HARTZELL PROPELLER INC.
SERVICE BULLETIN
TRANSMITTAL SHEET
HC-SB-61-311

Propeller - Replacement of 835-54(P) Spinner Assembly

This page transmits a revision to Service Bulletin HC-SB-61-311.

This revision is issued to change the following in the Service Bulletin:

Cutaway View of the 102965(P) Metal Spinner Dome (For Identification Only)

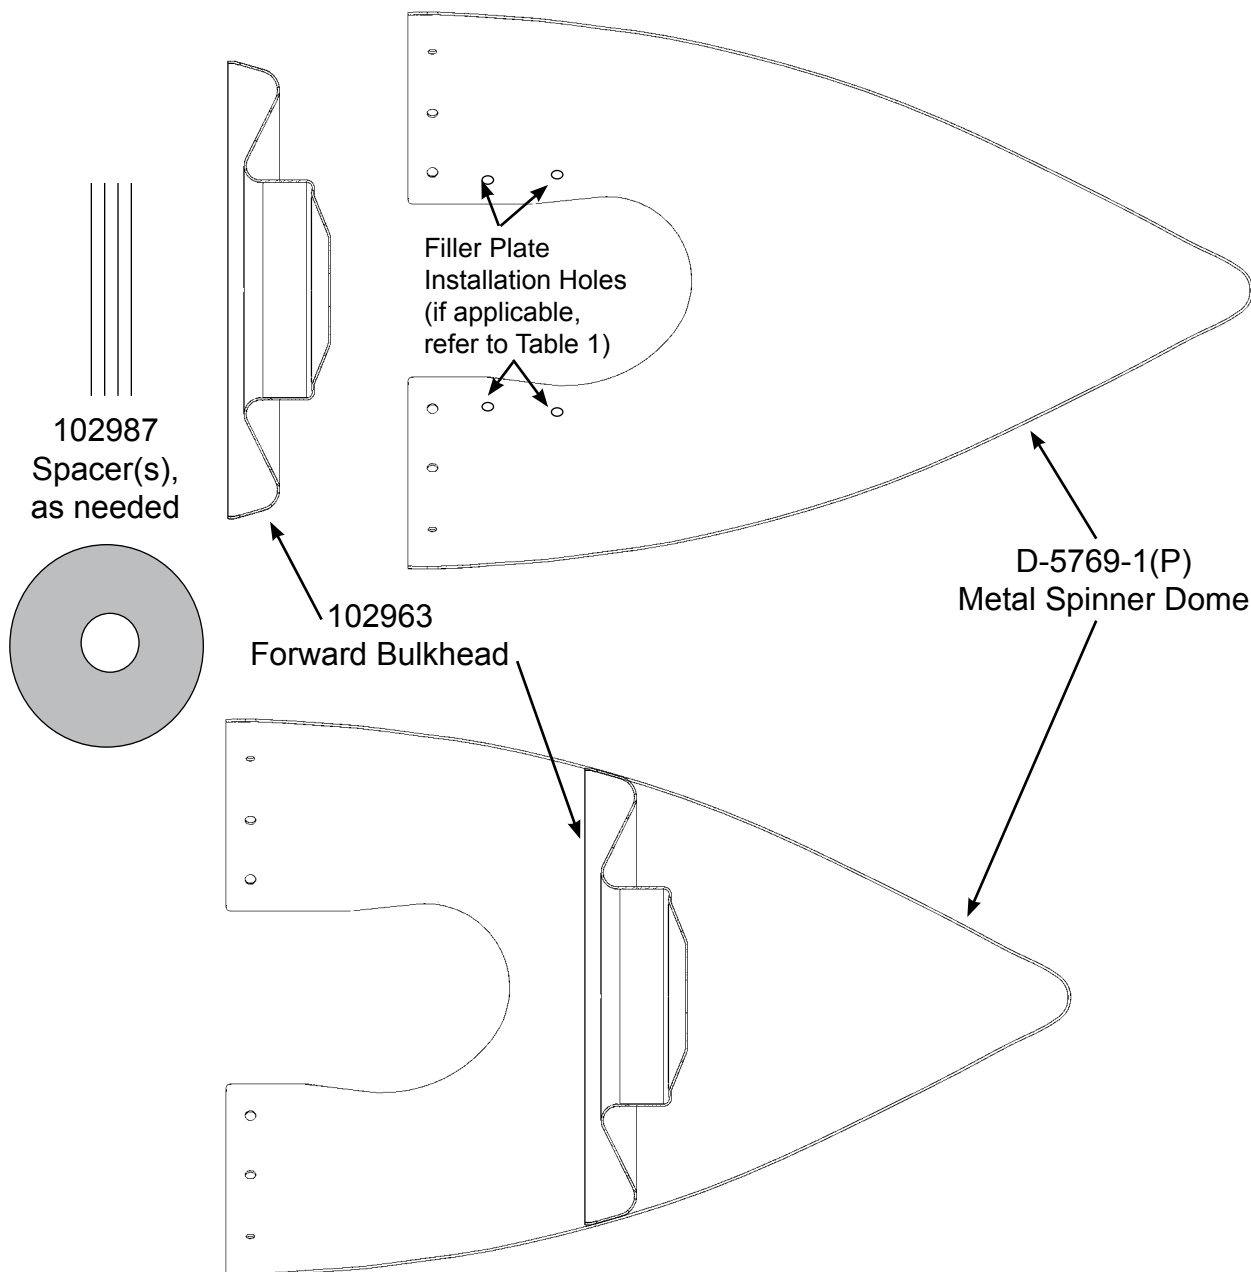
- (2) The original issue of this Service Bulletin introduced the 102965(P) metal spinner dome.
 - (a) The 102965(P) metal spinner dome incorporated a bonded front support to improve the stability of the dome, reduce vibration at the aft end of the dome, and improve the spinner dome reliability for reduced spinner dome cracking in the 835-54(P) spinner assembly. Refer to Figure 1.

**Cutaway View of the D-5769-1(P) Metal Spinner Dome,
with 102963 Front Bulkhead, and 102987 Spacer (For Identification Only)**
Figure 2

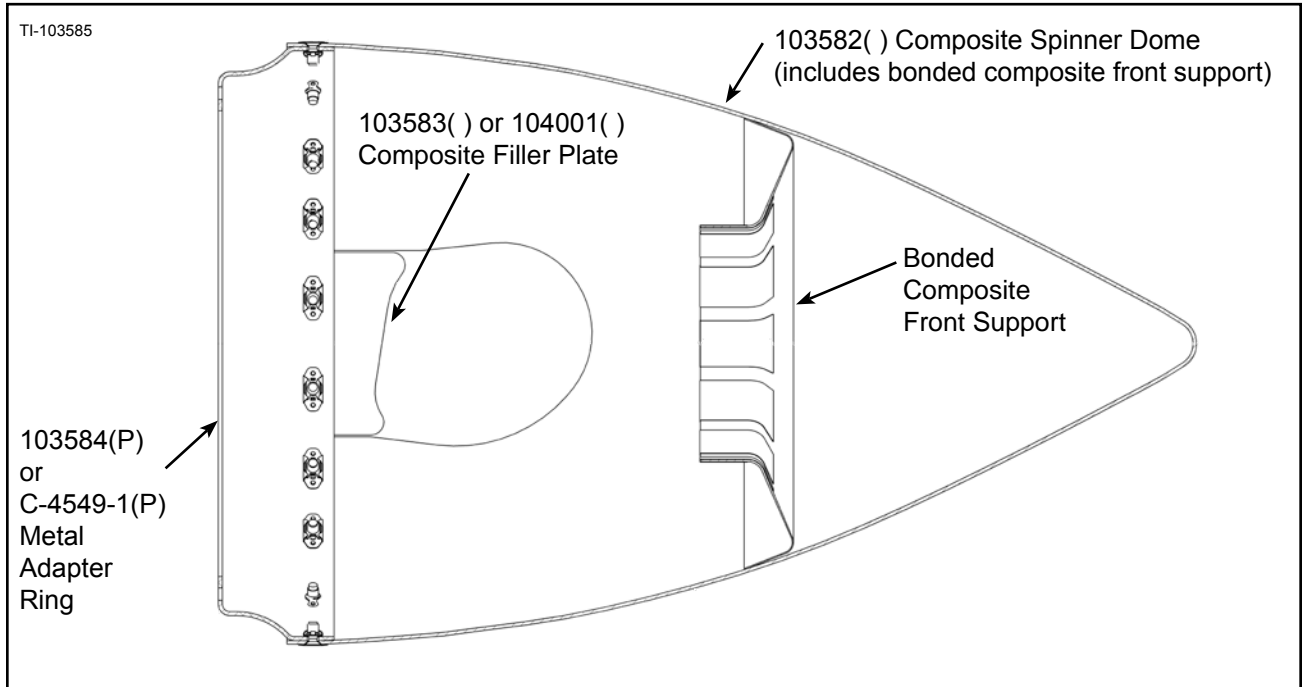
- (3) Revision 1 of this Service Bulletin introduced the 102963 installable forward bulkhead and the 102987 spacer for use with the D-5769-1(P) metal spinner dome to help prevent failure of the D-5769-1(P) metal spinner domes in use. Refer to Figure 2.

- (a) The 102963 installable forward bulkhead and the 102987 spacer were designed to provide stability to the D-5769-1(P) metal spinner dome, similar to the 102965(P) metal spinner dome, with bonded front support.

Cut-away View of the 103585() Spinner Assembly
Figure 3

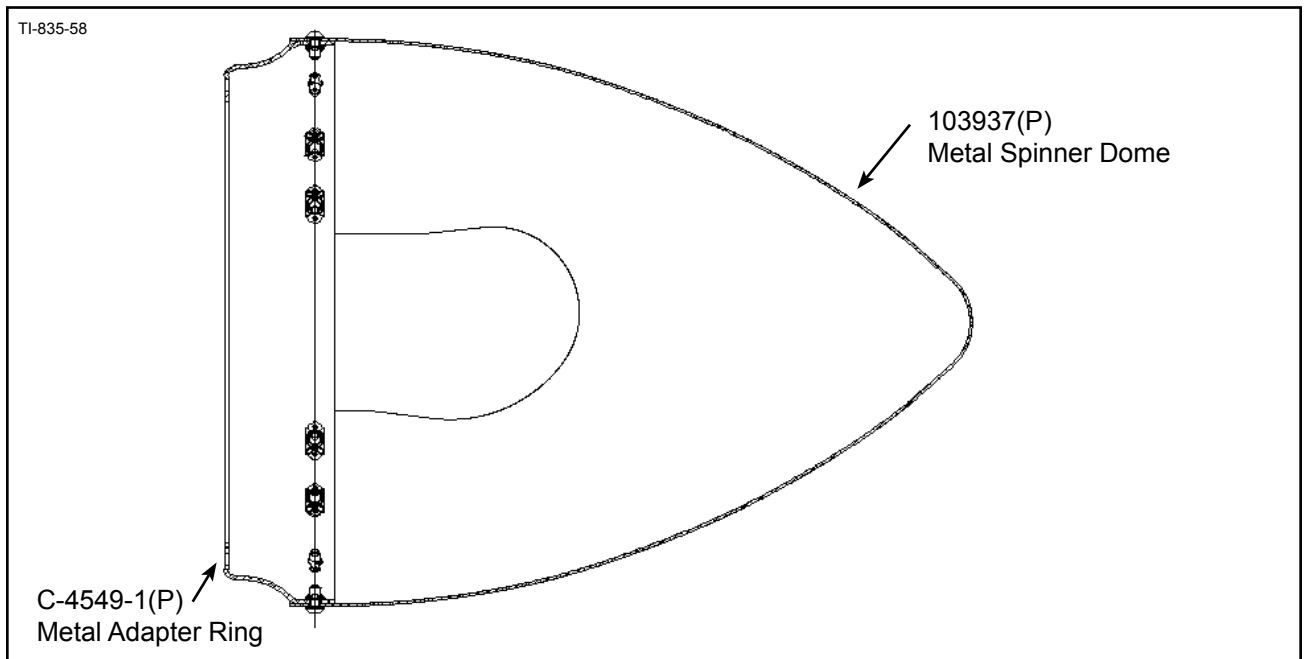
- (a) The 835-54(P) spinner assembly will no longer be manufactured and will not be procurable through Hartzell Propeller.
- (6) Revision 2 of this Service Bulletin introduced the new 103585() spinner assembly as a supersedure to the 835-54(P) spinner assembly in approved applications. Refer to Figure 3.

- (a) The 103585() spinner assembly includes a 103582() composite spinner dome with bonded front support, the 103583() or 104001() composite filler plates, and a 103584P metal adapter ring with assembly hardware.
 - (b) The C-4549-1(P) metal adapter ring, originally supplied with the 835-54(P) spinner assembly can be used in accordance with this Service Bulletin as an alternate to the 103584P metal adapter ring as a component of the 103585() spinner assembly.
- 1 When the C-4549-1(P) metal adapter ring is used in the 103585() spinner assembly, installation of the 103583() or 104001() composite filler plates is optional, but requires modification in accordance with the Accomplishment Instructions in this Service Bulletin.

Example Portion of the Retired Spinner Dome
Figure 5

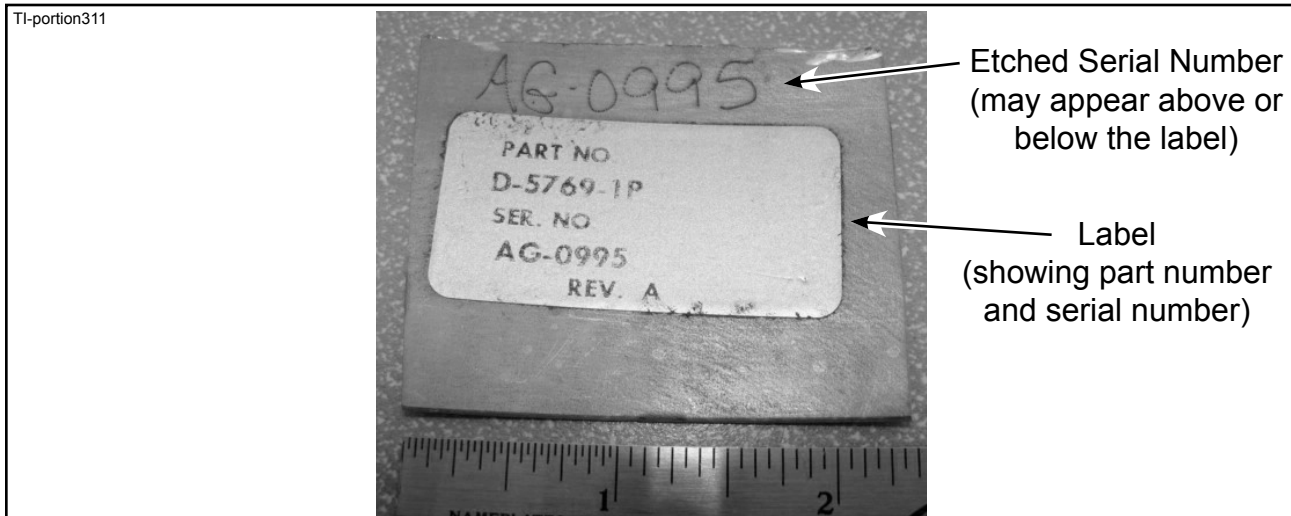
- c) These retired components must have a portion of the component cut out to include the part number and serial number. This portion must be returned to Hartzell Product Support.

C-4549-1(P) Metal Adapter Ring
Figure 6

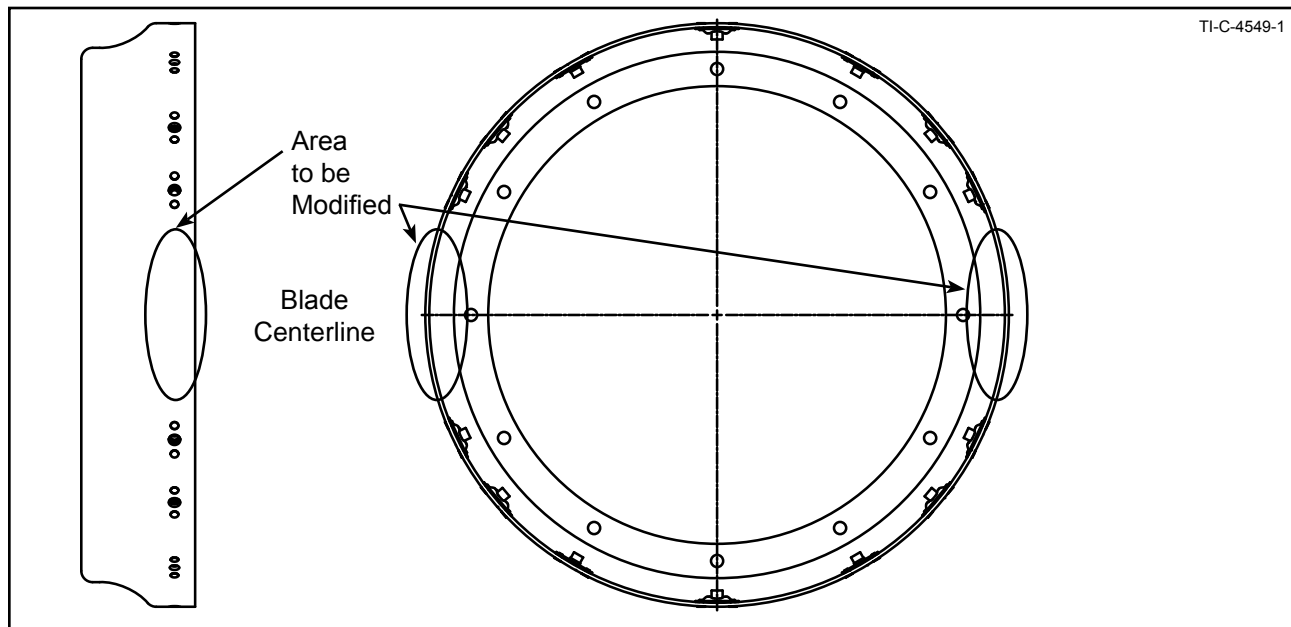
(c) The 103583() or 104001() composite filler plates may be installed at the owner/operator's option. If the filler plates will be installed, the metal adapter ring must be modified from the C-4549-1(P) to the 103584(P).

- (d) Hold one of the 103583() or 104001() composite filler plates in place, centered in one of the blade cut-out holes, flush with the bottom edge of the adapter ring, aligning the filler plate attachment holes with the row of assembly screws around the dome. Refer to Figure 6 and Figure 8.

- (i) On the inside diameter of the C-4549-1(P) metal adapter ring, hold one (1) B-3849-3 floating nutplate so that the nutplate is oriented in the same direction as the other nutplates on the inner diameter of the adapter ring and the filler plate attachment hole is aligned with the other assembly holes and with the newly drilled hole. Refer to Figure 6, Figure 7, and Figure 8.

103584(P) or Modified C-4549-1(P) Metal Adapter Ring
Figure 7

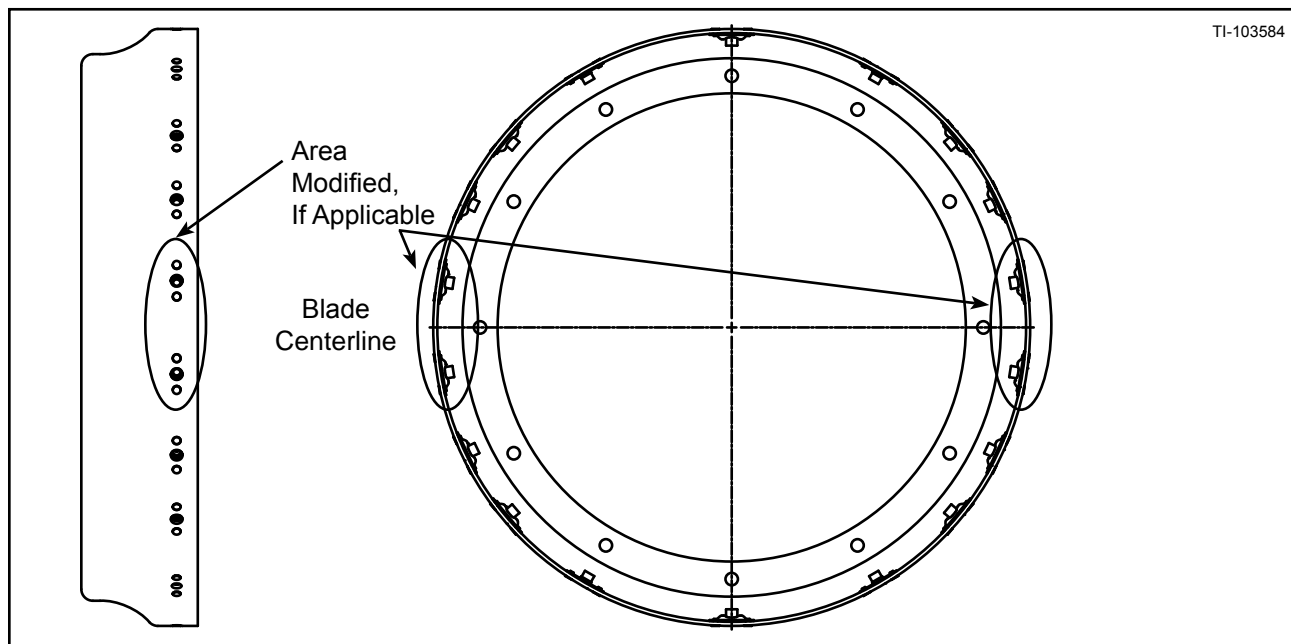
- 2 If the 103583() or 104001() composite filler plates will be installed with the C-4549-1(P) metal adapter ring, modification of the adapter ring is required in accordance with the Accomplishment Instructions of this Service Bulletin. Refer to Figure 6 and Figure 7.

NOTE: A C-4549-1(P) metal adapter ring can be modified into the 103584(P) metal adapter ring in accordance with this Service Bulletin. This configuration is approved for the 103585() spinner assembly in accordance with this Service Bulletin. The 103585() spinner assembly is only available for purchase from Hartzell with the 103584P (polished) metal adapter ring.

Metal Adapter Ring Identification Labels
Figure 9

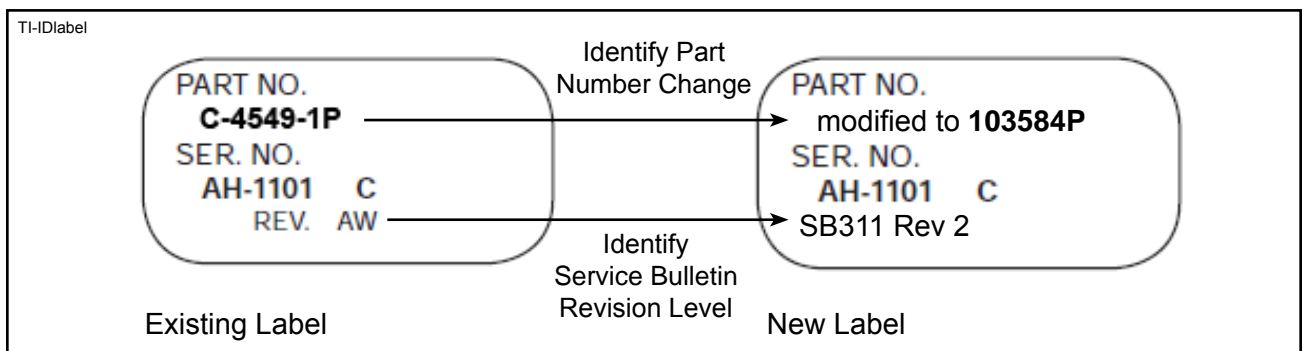
- 2 Type, print, or write on the label to provide the new, modified part number and the original serial number. Include the information as shown in Figure 9.
